Design Refinement 13 – Wickham Park Golf Club and River Meon

Figure 27 Wickham Park Golf Club and the River Meon – Summer 2024 Consultation design

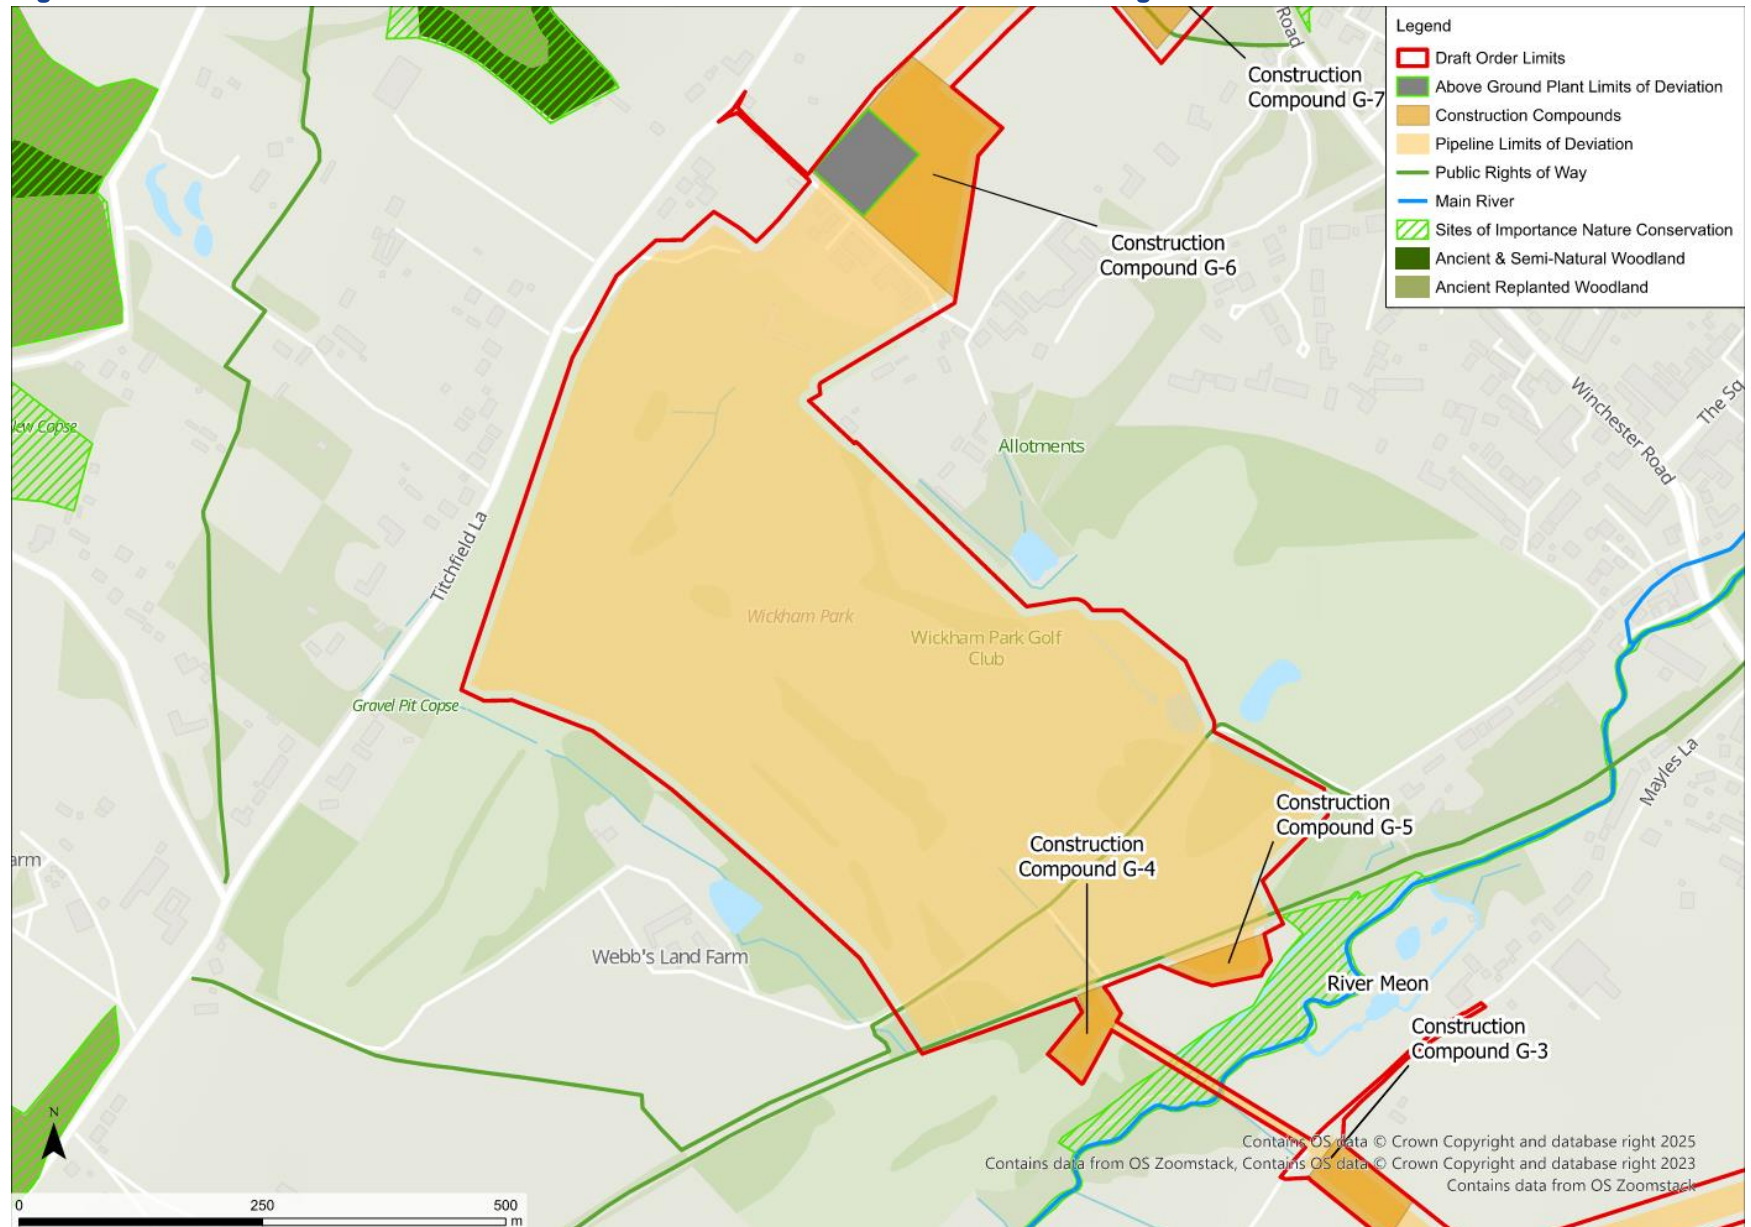
- Following the Summer 2024 Consultation, engagement with Wickham Park Golf Club has continued. In response to this, the draft Order Limits have been reduced, excluding much of the southern part of the golf course, as it intended that the pipeline will be located in the north east of the golf course and to the east of the clubhouse. An access track to the east of the clubhouse has also been included in the draft Order Limits and draft Limits of Deviation, as this area may be used to construct and install the pipeline. The draft Order Limits have also been extended to include the full extent of another golf club access track up to the boundary of Titchfield Lane, which is proposed to be used as a temporary construction access.

- Through ongoing design development, a second option for the trenchless crossing of the River Meon has been identified to the east of the trenchless crossing presented at the Summer 2024 Consultation. The new eastern trenchless crossing would utilise the same construction compounds shown at the Summer 2024 Consultation. The northern end of the eastern trenchless crossing option terminates in Wickham Wastewater Treatment Works which is a Southern Water asset. The draft Order Limits now include this new option. Including both crossing options within the draft Order Limits provides flexibility to find the least impactful route across the golf course. Only one crossing option would of course be constructed.
